ADDENDUM No. 2

RFP No. 25-57

SOUTH MAPLE PARK AND DEXTER PARK IMPROVEMENTS

**ANN ARBOR PARKS & RECREATION
DEXTER COURT & PAVILION**

HMA COURT PAVEMENT DETAIL (ALTERNATE)
NOT TO SCALE

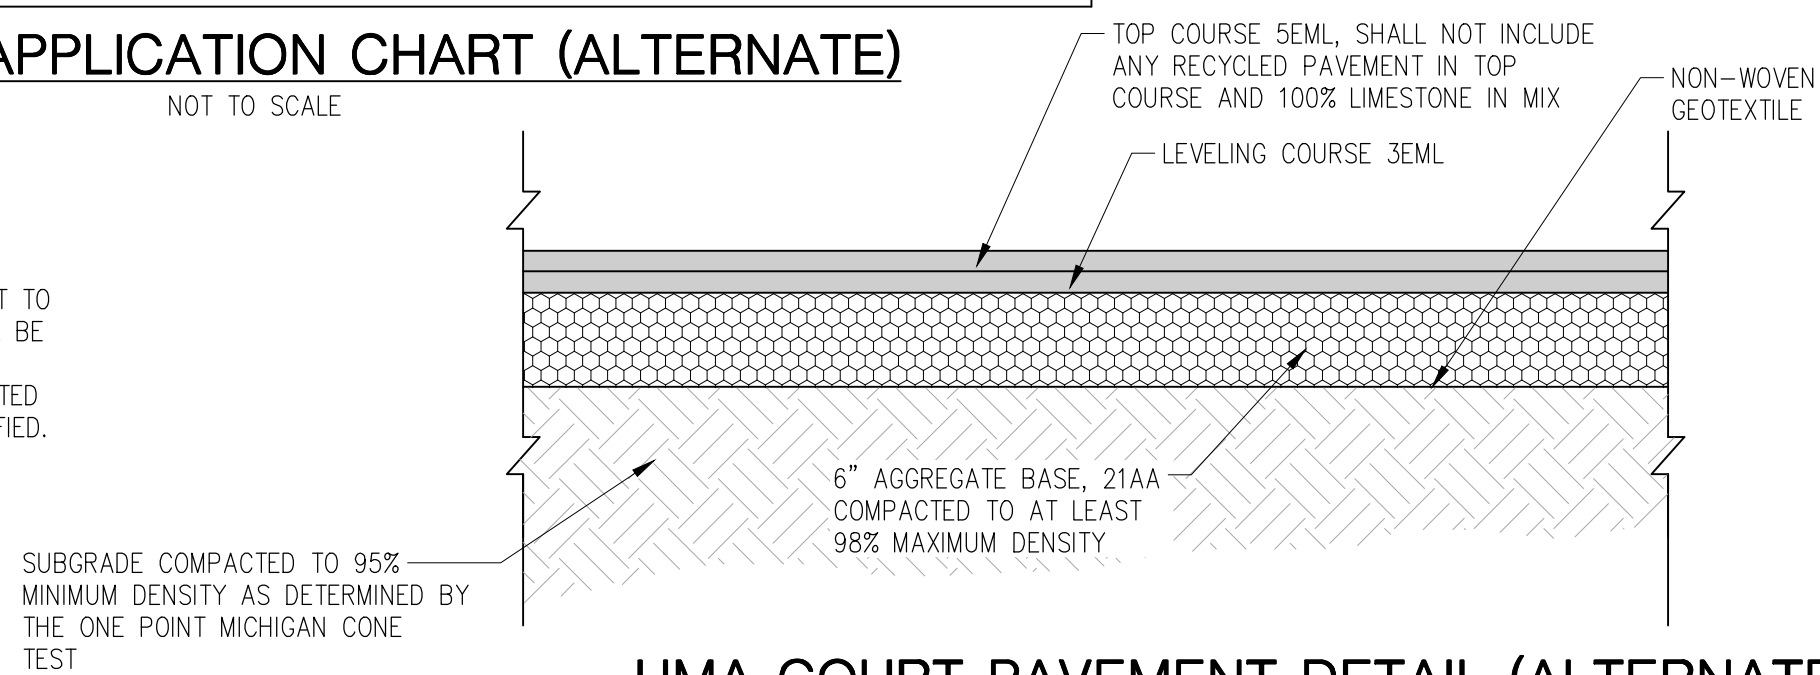
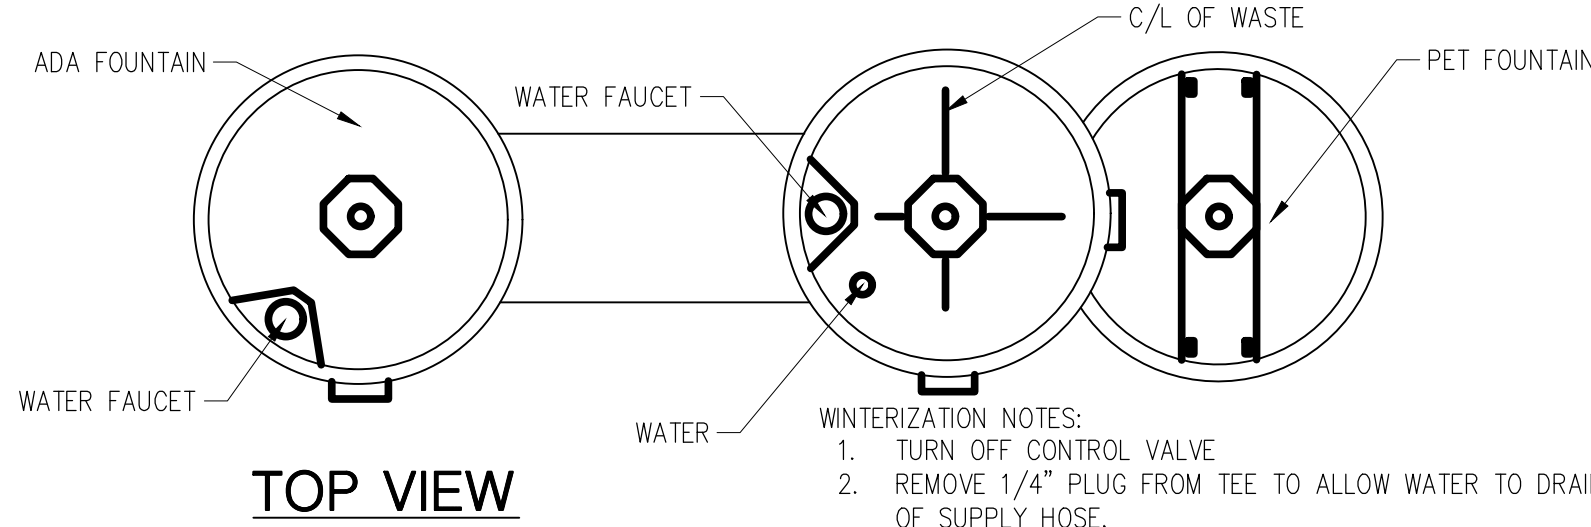
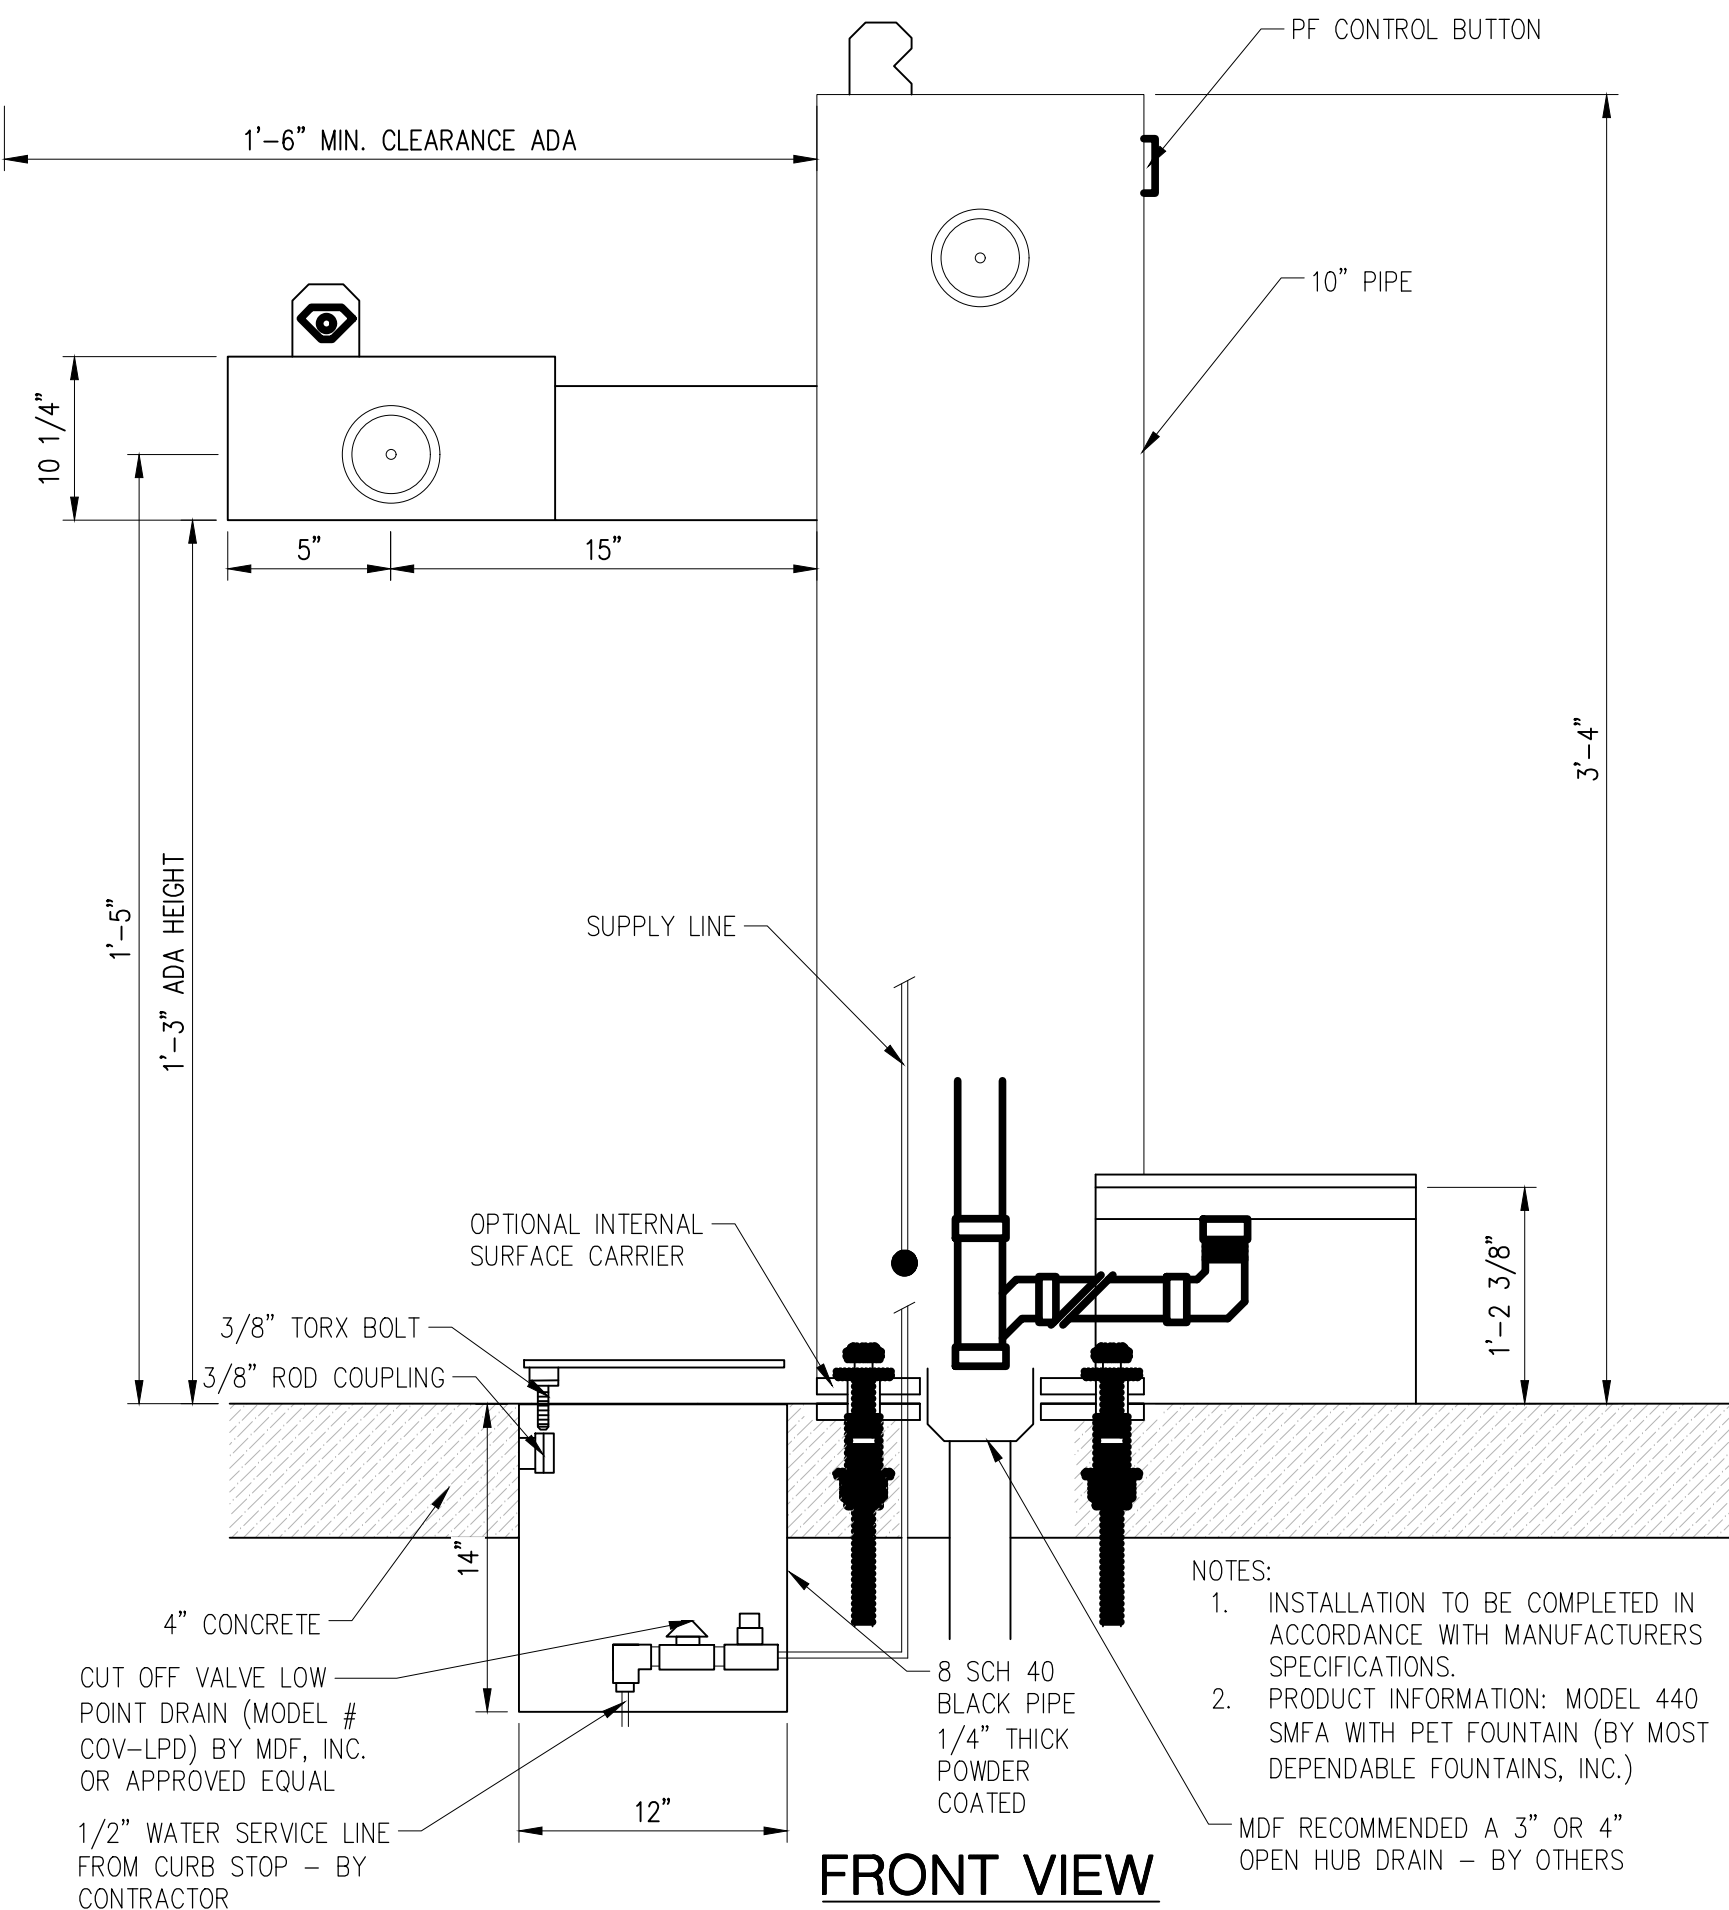
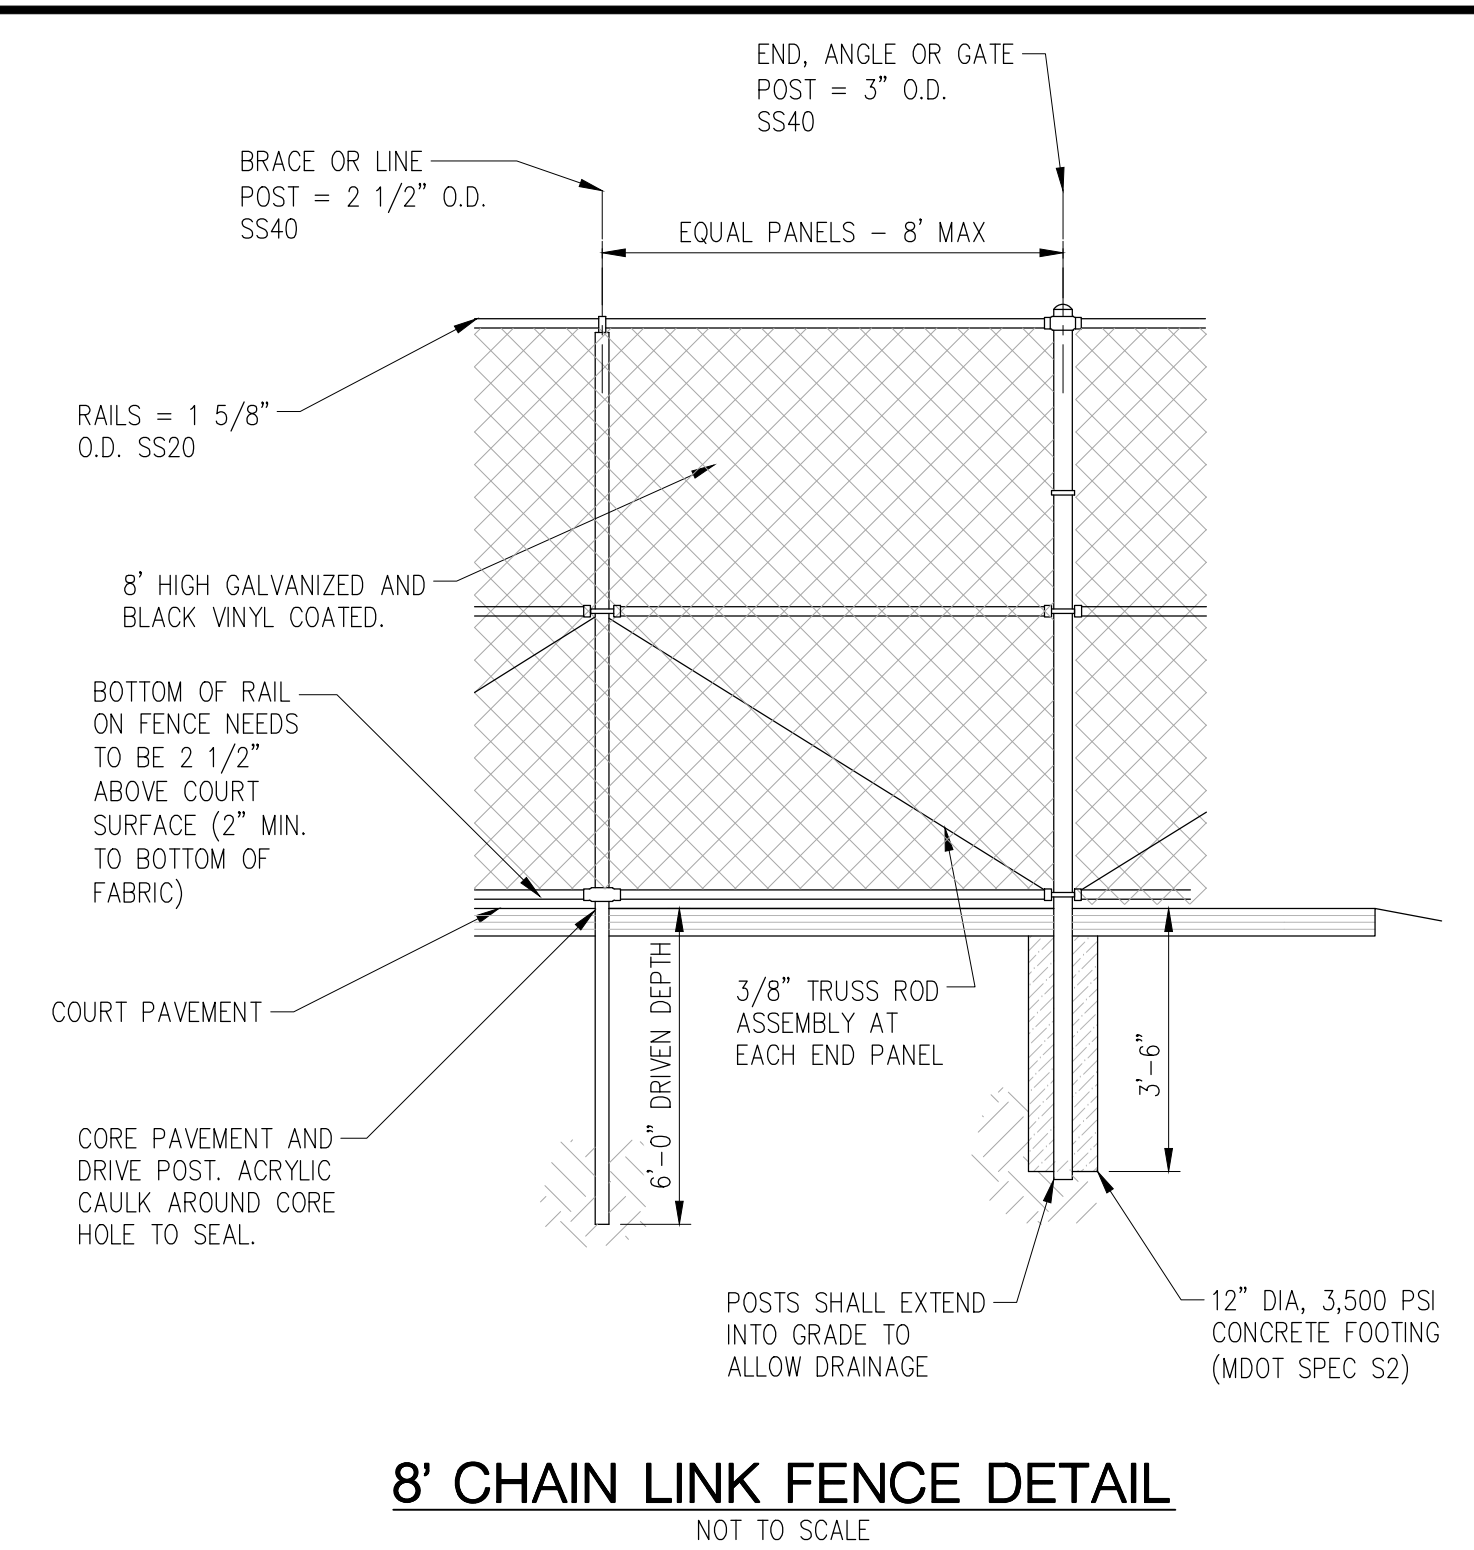
Question 2: Can clarification on the thickness and quantities of HMA paving alternate for Dexter Park be provided?

Answer 2: Yes, the thickness of the HMA alternate at Dexter Park is 3.5 inches. The Schedule of Pricing / Cost and Detail Sheet 5 have been replaced in its entirety through this addendum.

HMA PAVEMENT	RATE PER SYD	THICKNESS	PERFORMANCE GRADE	REMARKS
5EML (TOP)	165 LBS/SYD	1.5"	58-28	RAP IS NOT ALLOWED; AGGREGATE SHALL BE 100% CRUSHED LIMESTONE
3EML (LEVELING)	330 LBS/SYD	2"	58-28	RAP SHALL BE LIMITED TO TIER 1 DESIGN (17% MAX RAP BY BINDER WEIGHT)
BOND COAT 0.05 TO 0.15 GAL/SYD				
AGG. WEAR INDEX (AWI) SHALL BE 200 MIN FOR MAINLINE TOP COURSE
